Access Compliance Report

(Curb Ramps)

Intersection ID: 47645	Main Street: ALDWYCH_WY	Cross Street: WESTON_WOODS_LN	Location: NW
ADA ID: EABA5E5C2DDC	Ramp Type: PerpDiag	Initial Pass/Fail: Fail	Overall Compliance: No
Severity Score: 8.75			
Codes/Mitigation Info/Possible Solution		Field Measurements/Component Compliance

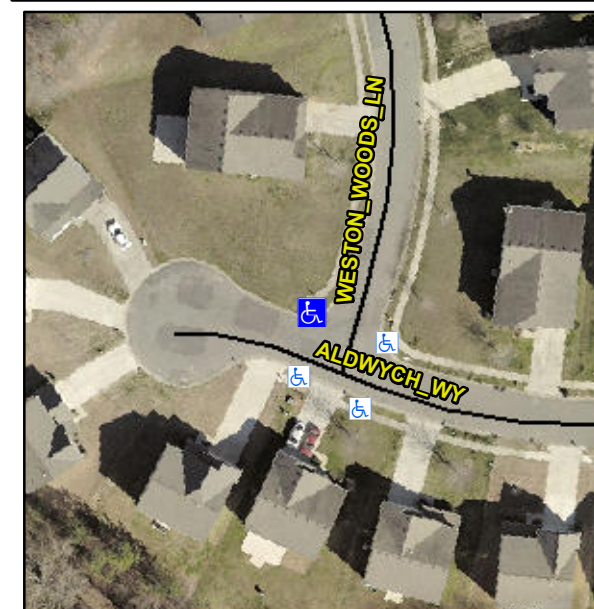
R304.5.1

Compliance	Description	Data	Compliance	Description	Data
N/A	Ramp Length (in)	53.0	Yes	Ramp Slope (%)	6.4
No	Ramp Width (in)	47.0	Yes	Ramp XSlope (%)	1.5
N/A	Flare Type LT	N/A	N/A	Flare Type RT	N/A
N/A	Flare Slope LT (%)	N/A	N/A	Flare Slope RT (%)	N/A
N/A	Flare Traversable LT?	N/A	N/A	Flare Traversable RT?	N/A
N/A	Landing Length (in)	N/A	N/A	DWS Provided?	N/A
N/A	Landing Width (in)	N/A	N/A	DWS Contrast?	N/A
N/A	Landing Slope (%)	N/A	N/A	DWS Length (in)	N/A
N/A	Landing X Slope (%)	N/A	N/A	DWS Full Width?	N/A
N/A	Landing Curb? (Y/N)	N/A	N/A	DWS Offset (in)	N/A
N/A	Shared Landing?	N/A			
N/A	Gutter Ponding?	N/A	N/A	Gutter Slope (%)	N/A
N/A	Gutter Lip Ht (in)	N/A	N/A	Gutter X Slope (%)	N/A
N/A	Painted X Walk1?	No	N/A	Painted X Walk2?	No
	X Walk 1 Direction	To SW		X Walk 2 Direction	To SE
N/A	X Walk 1 Width (in)	N/A	N/A	X Walk 2 Width (in)	N/A
	X Walk 1 Slope (%)	1.3		X Walk 2 Slope (%)	0.2
	X Walk 1 X Slope (%)	2.4		X Walk 2 X Slope (%)	0.5

Remove & Replace Curb Ramp With Two New Directional Ramps or Equivalent.
